550 Ashton New Road, Manchester M11 4AA

NMA for landscaping amendments pursuant to 141779/JO/2024

MANCHESTER CITY WOMEN'S 1ST TEAM FACILITIES – Landscape Updates 12th September 2025
 Approved SLD Dwg 407-71D General Arrangements

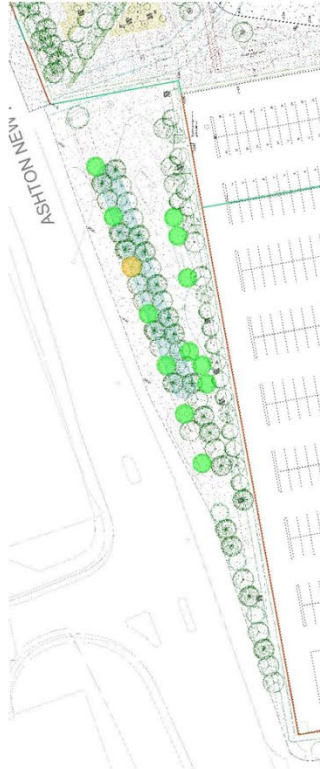
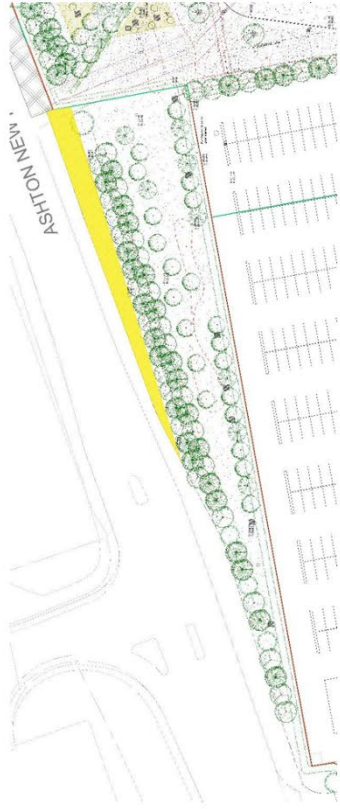
1. **M&E** - The concrete base that accommodates external plant to the rear of the building needs to be slightly extended (by circa 12m²) to accommodate the revised external plant layout.

2. **Gas easement** - The profile of the landscape bund over the gas easement has been reduced in depth by circa 800mm following liaison and as agreed with United Utilities (from 2 metres to 1.2 metres maximum).

3. **Substation** - The proposed landscaping plans have been amended to incorporate the substation that was approved separately (140967/FO/2024) and reflect the arrangements agreed with the service provider.

4. **Footpath specification** - The detailing of the footpath surface finish specification has been identified and illustrated on the general layout plan drawing ref 407-71H as Rolled Asphalt, following discussions with Manchester City Council Highways department.

5. **Line of trees** – The detailed design has identified that there is insufficient space between the proposed attenuation tank and kerb line (1.2 metres) along the rear of the carpark to accommodate enough soft landscaping for the previously proposed hedge and tree planting to be established in this location. The proposed submission therefore removes this row of proposed trees and

6. **Retained trees** - The detailed design has managed to retain more of the existing trees on site. An additional 13 trees are able to be retained and so there is a reduction in the number of replacement trees required (reduction of 26 replacement trees).

The existing Turkish Hazel tree G3.1 in AIA is to be removed as it is showing signs of poor health. This tree will be replaced with a semi mature specimen that matches the existing established trees in this area. Nine trees are proposed to be relocated from the existing car park to the POS as set out in 5 above.

The size and location of the main contractor's compound has reduced and therefore allowed for the retention of more existing trees in the POS. The location of proposed trees aligns with the existing linear belt of Turkish hazels.

7. **Wildflower mix / specification** - The location and specification of the wildflower meadow mix has changed following a request from the Club's ground maintenance team. The location of the wildflower meadow is now proposed (at the same scale) beneath the woodland belt to ensure that the maintenance of the grassed areas can be more readily undertaken.

The specification of the wildflower has been amended to provide a shade tolerant mix, consistent with the revised location within the tree canopies and to align the landscaping plans with the wider Etihad Campus Landscape Strategy.

Item	Location	Change	Reason	Approved Layout	New Layout
1	External Plant	Concrete base increased to external plant located to the rear of the new building.	External plant layout updated for M&E purposes.		
2	Earthworks	Earthworks layout & levels amended.	Gas easement location updated to agreed proposals with UU. Cover levels reduced over easement from 2m+ to 1.2m maximum as specified by UU.		
3	Substation	Substation proposals included in landscape general arrangements.	The substation was introduced into the layout as part of the coordinated design process, ensuring project continuity and reflecting the arrangements agreed with the service provider.

Item	Location	Change	Reason	Approved Layout	New Layout
4	Ashton New Road	Footpath surface finish specification added to layout. Rolled Asphalt.	Surface finish updated following discussions with MCC Highways department.

Item	Location	Change	Reason	Approved Layout	New Layout
5	Existing car park	Proposed line of trees removed and relocated in POS on Ashton New Rd.	Max width between the tank and kerb is 1.2m, therefore there is insufficient space between the attenuation tank and kerb line to provide adequate soft landscaping for hedge and tree planting to establish in a healthy manner.

Item	Location	Change	Reason	Approved Layout	New Layout
6	Ashton New Rd POS 	Locations of proposed trees updated 13no existing trees (green circle) that were originally to be removed are now retained. There is therefore a reduction of 26no replacement trees on site. Existing Turkish Hazel tree, G3.1 in A/A, is to be removed (orange circle & photo) as this is showing signs of poor health. This tree will be replaced with a semi mature specimen that matches the existing established trees in this area. 9no trees moved from Item5 added to the POS.	Main contractors site compound size and location allowed the retention of the existing trees in the POS. Locations of proposed trees moved to align with existing linear belt of Turkish Hazels. Additional trees added to the POS as explained in Item5. Locations of proposed trees updated following confirmation of existing site services in western section of POS.

Item	Location	Change	Reason	Approved Layout
7	Ashton New Rd POS	Location and specification of wildflower meadow mix changed.	Request from the client's grounds maintenance team to locate the wildflower beneath the woodland belt to facilitate maintenance of the grassed areas. Wildflower specification amended to shade tolerant mix due to location beneath tree canopies and to align with wider Etihad Campus landscape strategy. Approved m2 of wildflower meadow is retained.	 Approved Layout  New Layout
